Gate Burton Energy Park

EN010131

8.10 Access Updates and Cumulative Impact Assessment
August 2023

This Technical Note describes the process undertaken to minimise environmental impacts associated with accesses since submission of the DCO application and details the changes that have been made to further reduce impacts. It has been prepared for submission at Deadline 2 in the Examination (8 August 2023).

Figure 6: A156 High Street East Access Junction Layout

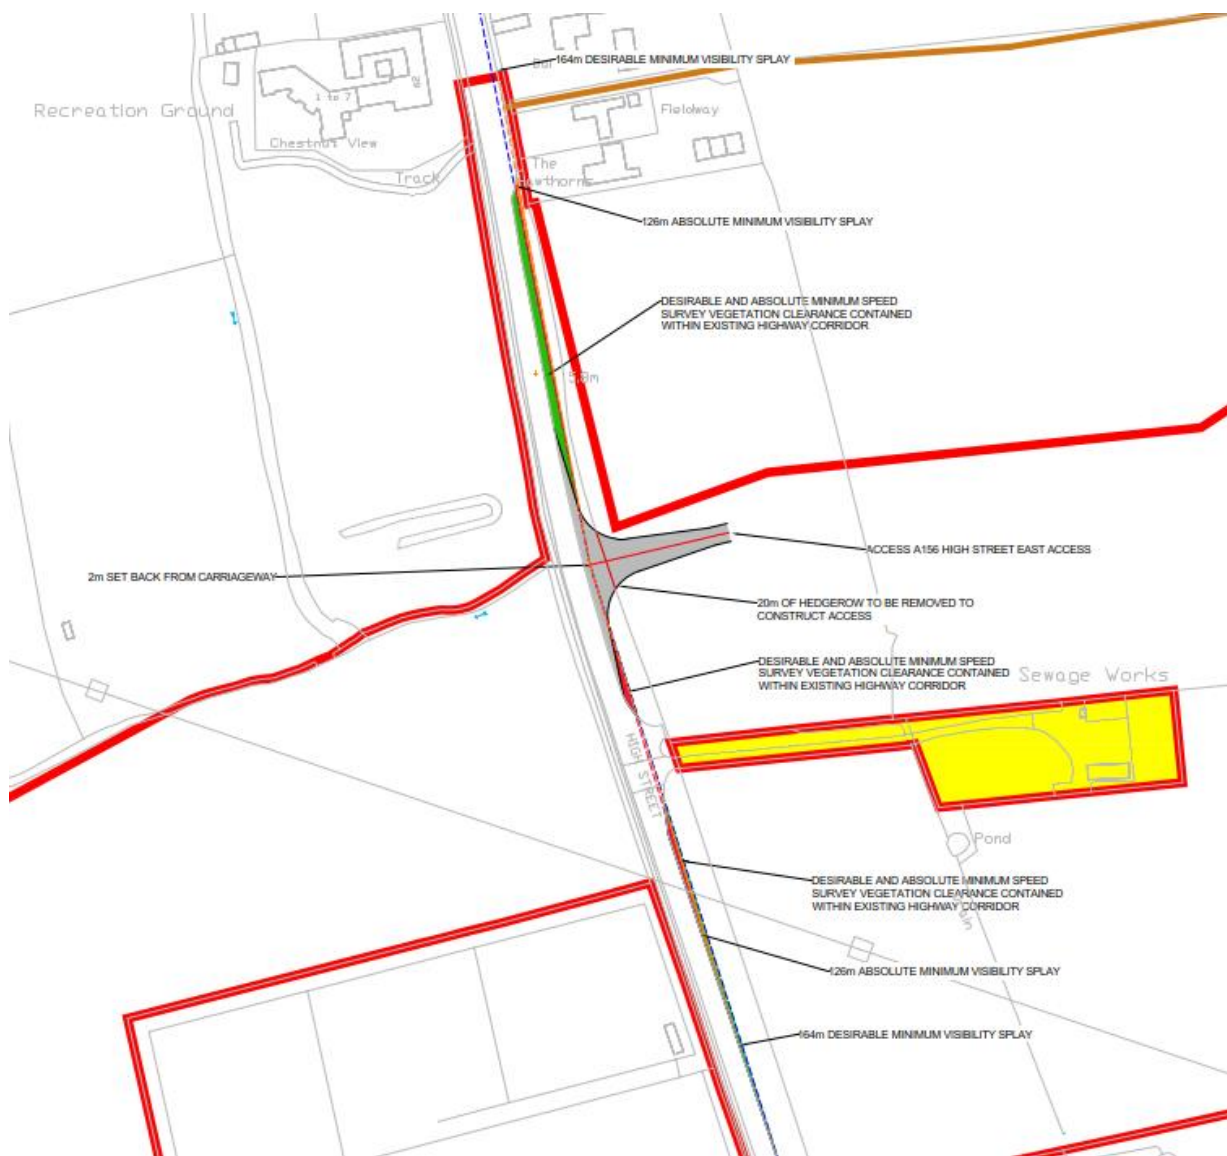
- 3.1.5 The proposed access junction has been designed in accordance with DMRB Standard CD123 Rev 2.1.0. The proposed layout is as shown in [Figure 6](#). Visibility proposed within the DCO layouts showed visibility splays in accordance with DMRB CD109 Rev 1 Table 2.10 desirable minimum SSD. With a posted speed of 50mph for this section of highway, a design speed of 85kph was adopted, giving a visibility requirement of 160m for SSD. However, it is noted that SSD of 215m in accordance with a design speed of 100kph is achieved within the highway boundary due to relatively straight nature of the A156 in this region.

- 3.1.8 Following a speed survey being undertaken and documented in the Transport Assessment Report [\[APP-166/3.3\]](#), the junction visibility was reassessed using the 85th Percentile speeds. [Table 3](#) outlines the visibility distances assessed and the associated hedgerow clearance to achieve those splays.

3.1.12 Access drawing 60664324-HGN-DR-CH-0008 presented in the Framework Construction Traffic Management Plan **[APP-167/3.3]** has therefore been updated to reflect the revised visibility requirement of 164m and issued as part of the Applicant's Deadline 2 submission.

Figure 10: A156 High Street West Access Junction Layout

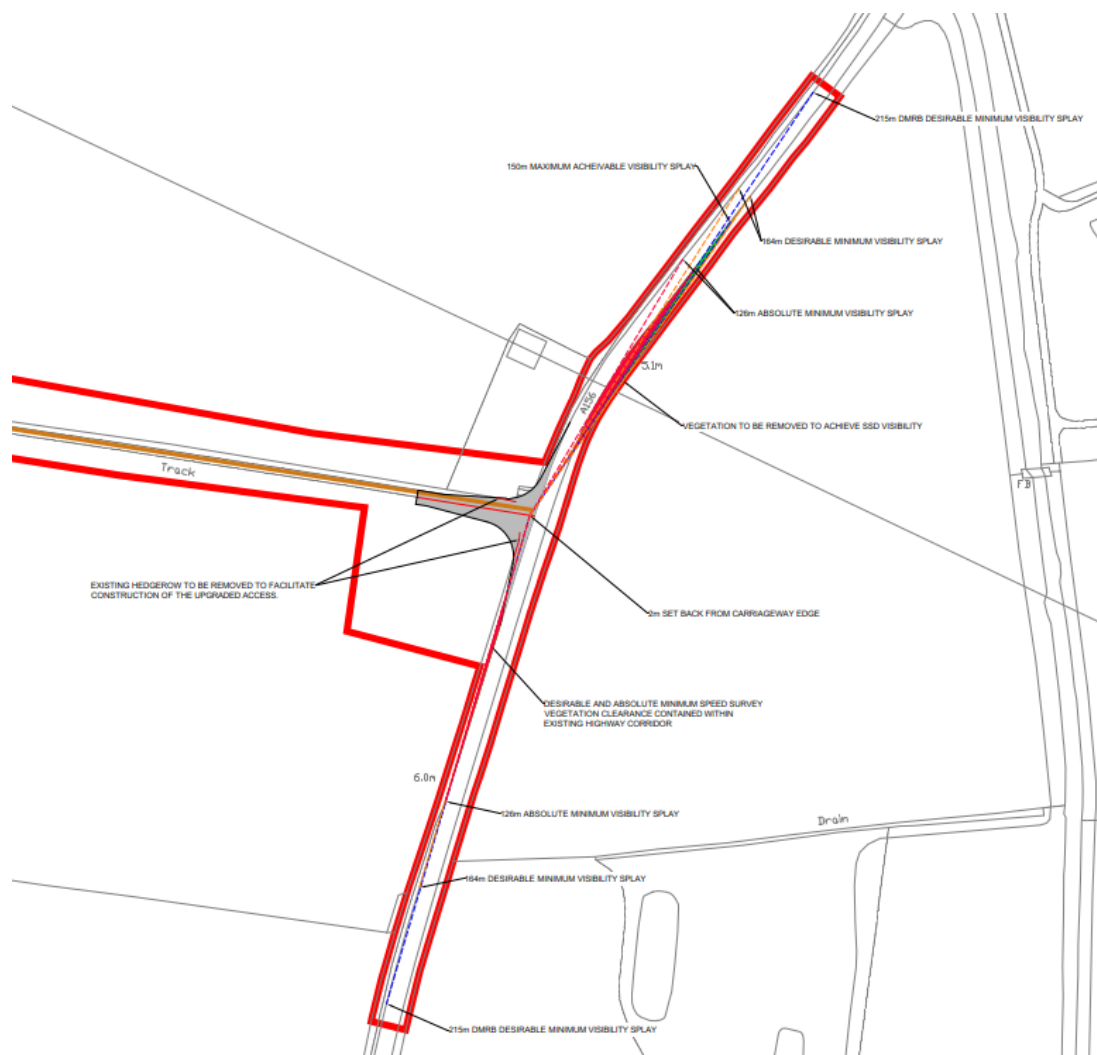
- 4.1.6 The proposed access junction has been designed in accordance with DMRB Design Standard CD123 Rev 2.1.0. The proposed layout is as shown in [Figure 10](#). Visibility proposed within the DCO layouts show visibility splays in accordance with DMRB CD109 Rev 1 Table 2.10 desirable minimum SSD of 215m applicable to a design speed of 100kph.

- 4.1.10 Following a speed survey being undertaken and documented in the Transport Assessment **[APP-166/3.3]**, the junction visibility was reassessed using the 85th Percentile speeds. Table 4 outlines the visibility distances assessed and the associated hedgerow clearance to achieve those splays.

4.1.13 Following a meeting with LCC on 17 May 2023, and the information presented by the Applicant, LCC advised in their formal response on the 7 July 2023 that for the A156 High Street West Access, visibility requirements of Speed Survey Desirable Minimum should be adopted.

4.1.15 Access drawing 60664324-HGN-DR-CH-0003 presented in the Framework Construction Traffic Management Plan **[APP-167/3.3]** has been updated to reflect the revised visibility requirement of 164m and issued as part of the Applicant's Deadline 2 submission.

Figure 14: Kexby Lane South Access Junction Layout

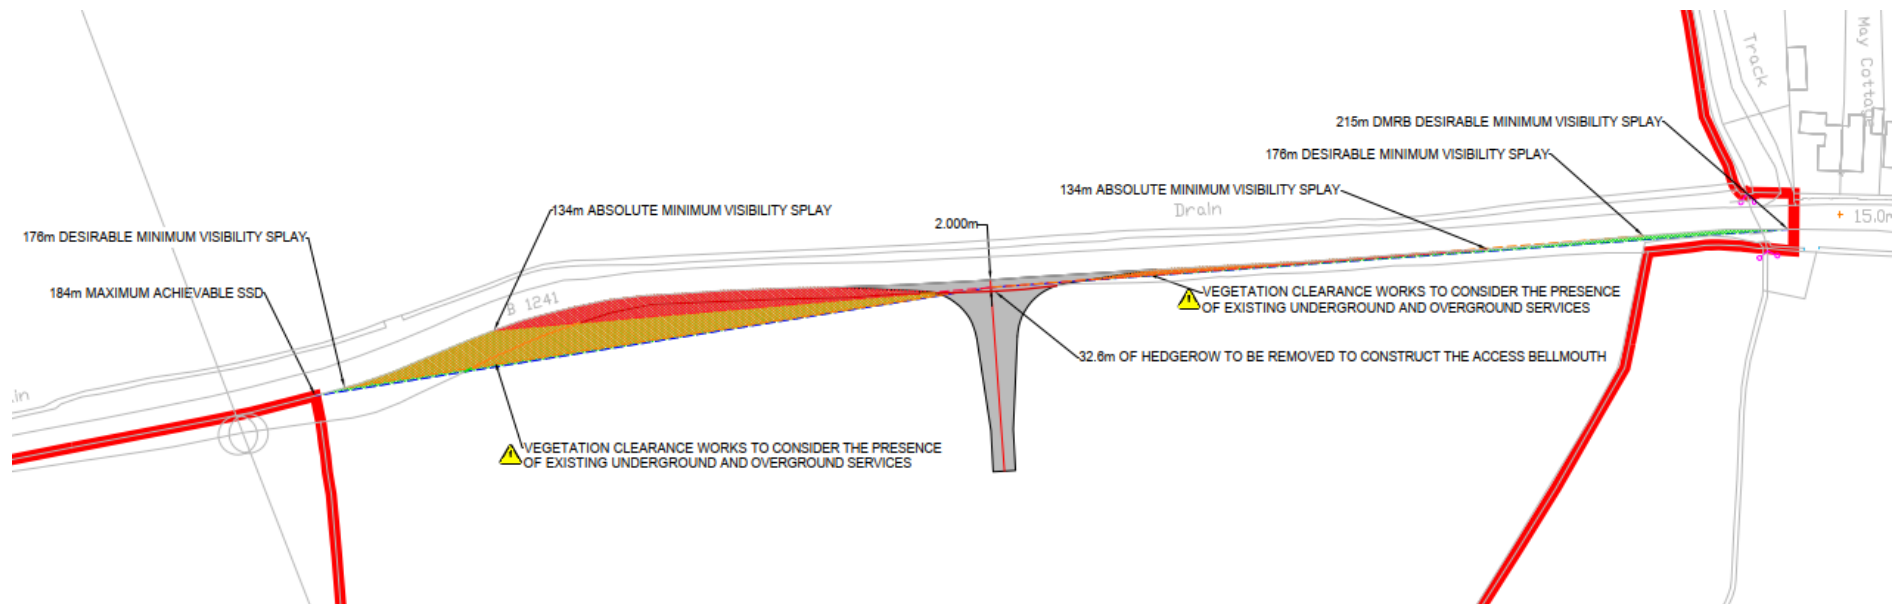
- 5.1.6 The proposed access junction has been designed in accordance with DMRB Design Standard CD123 Rev 2.1.0. The proposed layout is as shown in [Figure 14](#). Visibility proposed within the DCO layouts showed visibility splays in accordance with DMRB CD109 Rev 1 Table 2.10 desirable minimum SSD. With a posted speed of 60mph for this section of highway, a design speed of 100kph was adopted, giving a visibility requirement of 215m for SSD.

- 5.1.8 Following a speed survey being undertaken and documented in the Transport Assessment [**APP-166/3.3**], the junction visibility was reassessed using the 85th Percentile speeds. [Table 5](#) outlines the visibility distances assessed and the associated hedgerow clearance to achieve those splays.

- 5.1.14 Access drawing 60664324-HGN-DR-CH-0017 presented in the Framework Construction Traffic Management Plan **[APP-167/3.3]** has therefore been updated to reflect the revised visibility requirement of 134m and issued as part of the Applicant's Deadline 2 submission.

Figure 17: Kexby Lane North Access Junction Layout

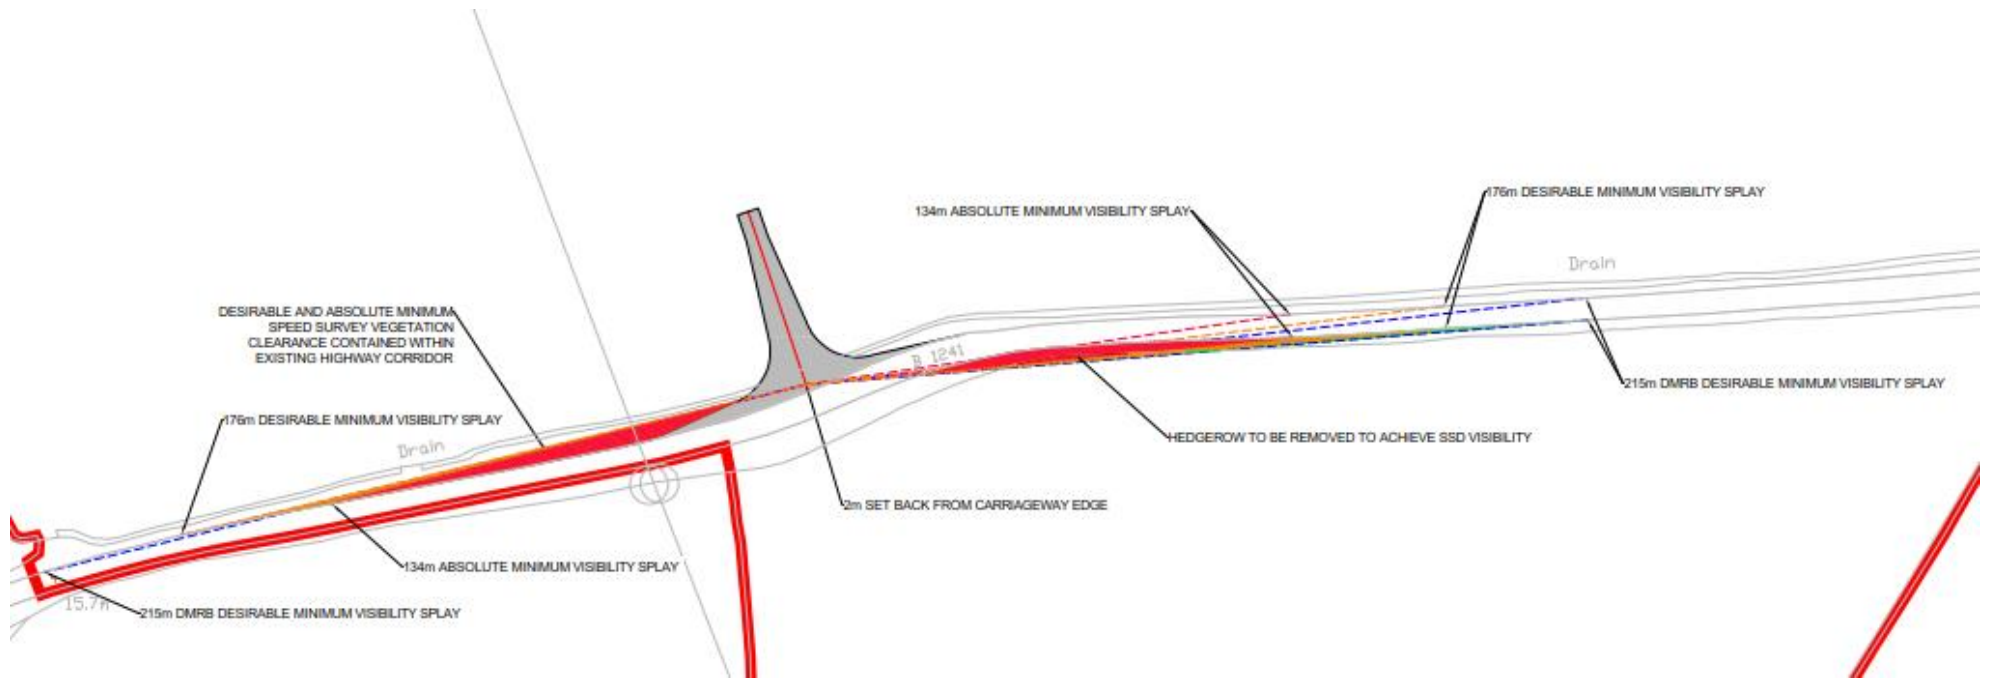
- 6.1.6 The proposed access junction has been designed in accordance with DMRB Standard CD123 Rev 2.1.0. The proposed layout is as shown in [Figure 17](#). Visibility proposed within the DCO layouts showed visibility splays in accordance with DMRB CD109 Rev 1 Table 2.10 desirable minimum SSD. With a posted speed of 60mph for this section of highway, a design speed of 100kph was adopted, giving a visibility requirement of 215m of SSD.

- 6.1.8 Following a speed survey being undertaken and documented in the Transport Assessment [**APP-166/3.3**], the junction visibility was reassessed using the 85th Percentile speeds. [Table 6](#) outlines the visibility distances assessed and the associated hedgerow clearance to achieve those splays.

6.1.13 Access drawing 60664324-HGN-DR-CH-0016 presented in the Framework Construction Traffic Management Plan **[APP-167/3.3]** has therefore been updated to reflect the revised visibility requirement of 134m and issued as part of the Applicant's Deadline 2 submission.

Figure 30: Headstead Bank East Access Junction Layout

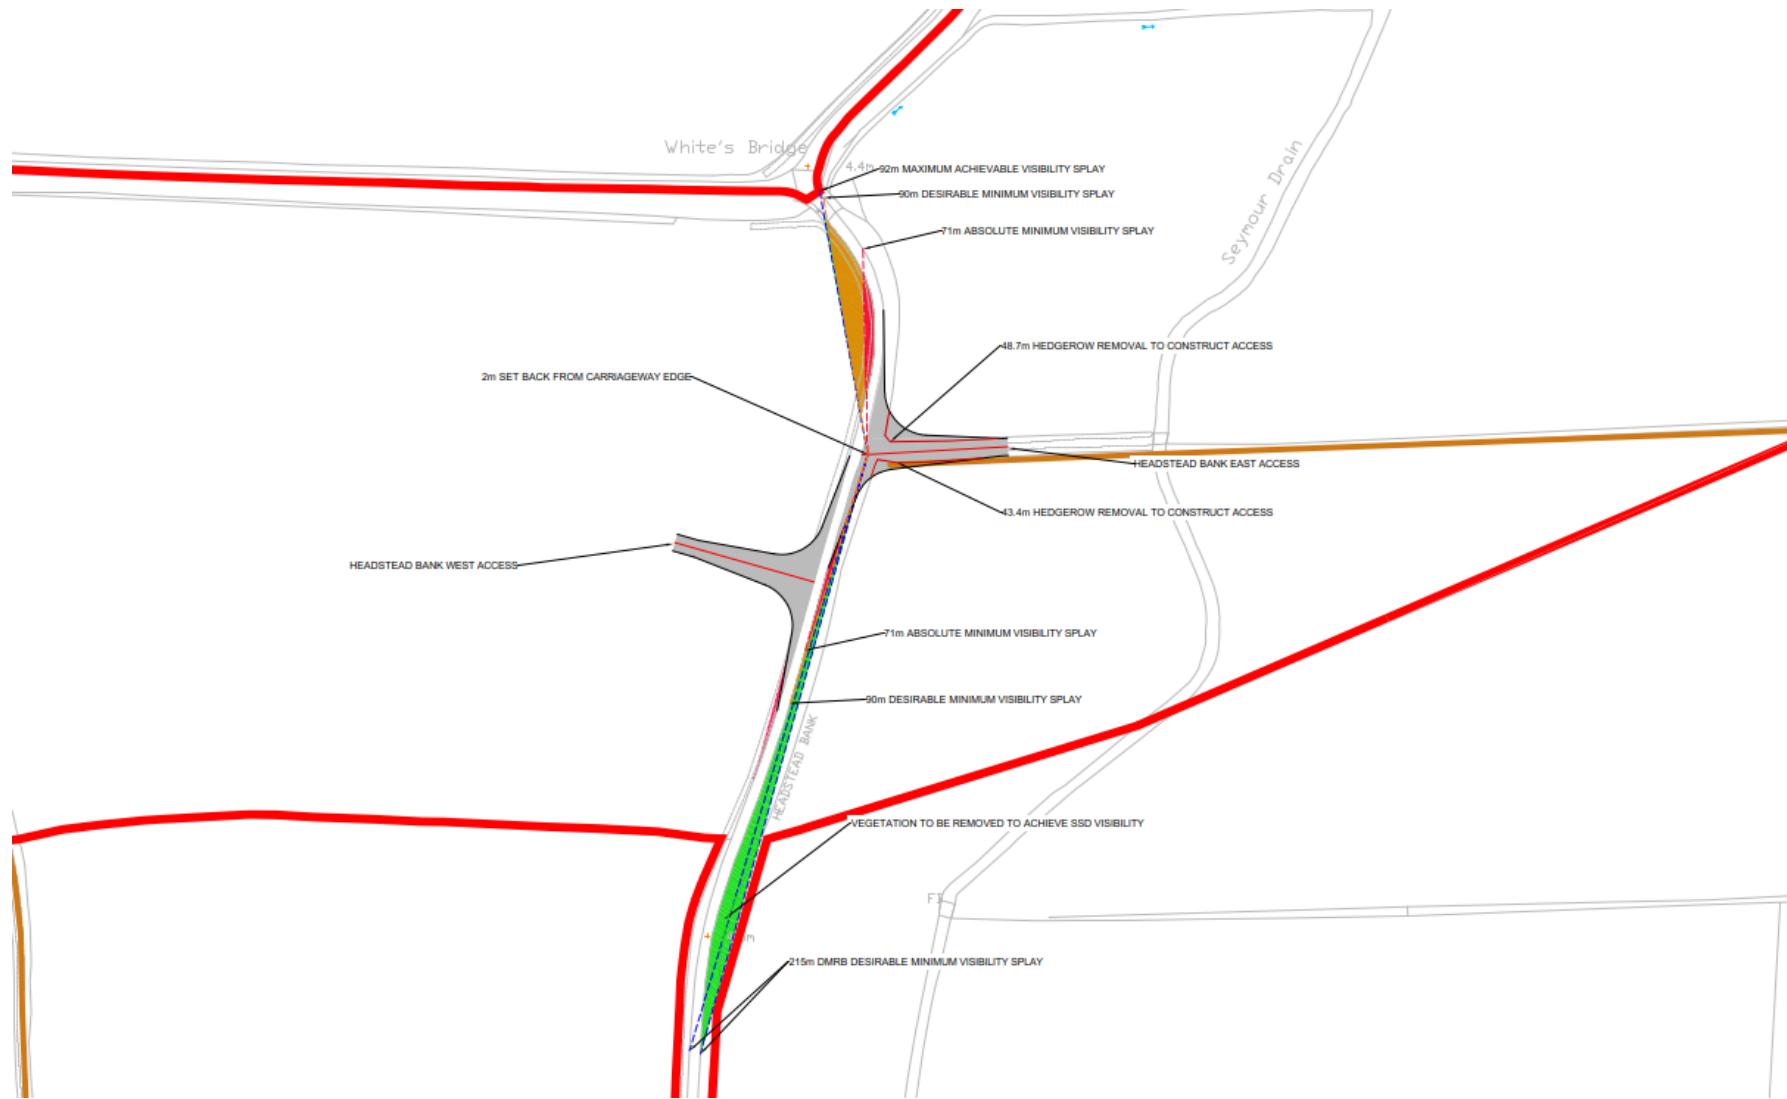
- 10.1.6 The proposed access junction has been designed in accordance with the DMRB CD123 Rev 2.1.0. The proposed layout is as shown in [Figure 30](#). Visibility proposals within the DCO layouts showed visibility splays in accordance with DMRB CD109 Rev 1 Table 2.10 desirable minimum SSD.
- 10.1.7 Headstead Bank does not have a posted speed limit within the vicinity of the access and therefore the National Speed Limit of 60mph would apply to this section of highway. Therefore, a design speed of 100kph was adopted, giving a visibility requirement of 215m for SSD. However, Headstead Bank is a single-track road between 3.5m and 4m wide at the access point. As such, vehicle speeds would be expected to be lower than 60mph, as confirmed by speed survey, see below.

10.1.14 Access drawing 60664324-HGN-DR-CH-0010 presented in the Framework Construction Traffic Management Plan **[APP-167/3.3]** have been updated to

Figure 34: Headstead Bank West Access Junction Layout

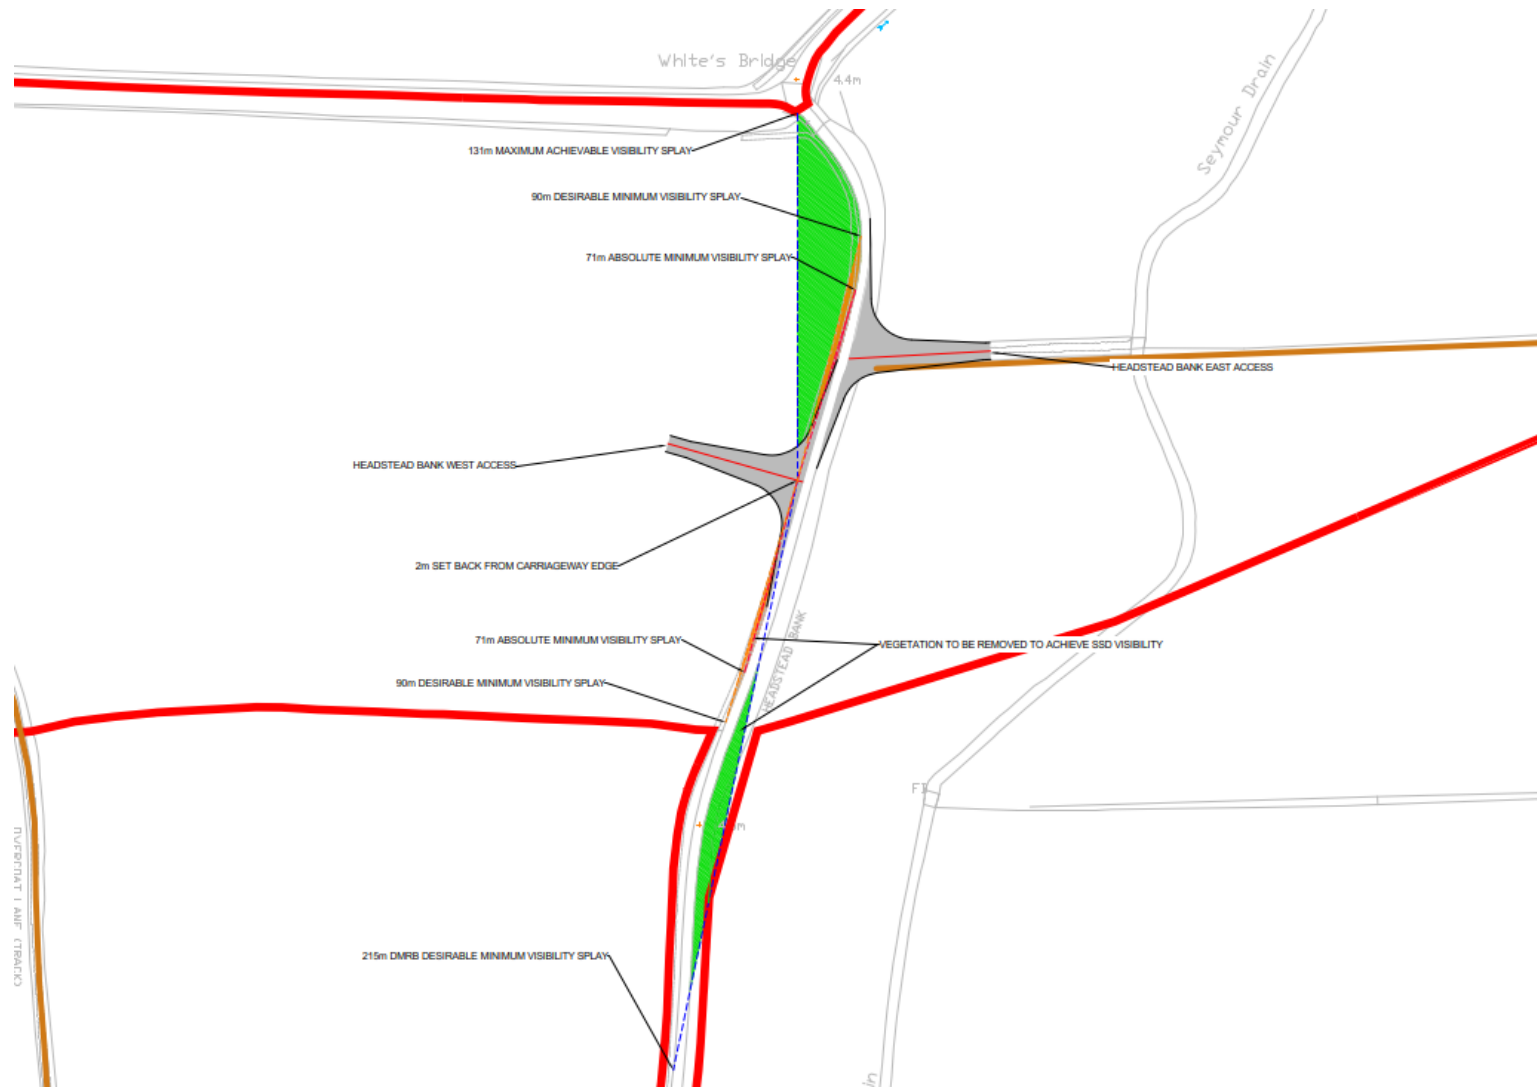
- 11.1.6 The proposed access junction has been designed in accordance with DMRB Standard CD123 Rev 2.1.0. The proposed layout is as shown in [Figure 34](#). Visibility proposed within the DCO layouts showed visibility splays in accordance with DMRB CD109 Rev 1 Table 2.10 desirable minimum SSD.
- 11.1.7 Headstead Bank does not have a posted speed limit within the vicinity of the access and therefore the National Speed limit of 60mph would apply to this section of highway, a design speed of 100kph was adopted, giving a visibility requirement of 215m for SSD. However, Headstead Bank is a single-track road between 3.5m and 4m wide at the access point. As such, vehicle speeds would be expected to be lower than 60mph, as confirmed by speed survey.

11.1.14 Access drawing 60664324-HGN-DR-CH-0011 presented in the Framework Construction Traffic Management Plan [APP-167/3.3] has therefore been updated to reflect the revised visibility requirement of 90m and issued as part of the Applicant's Deadline 2 submission.
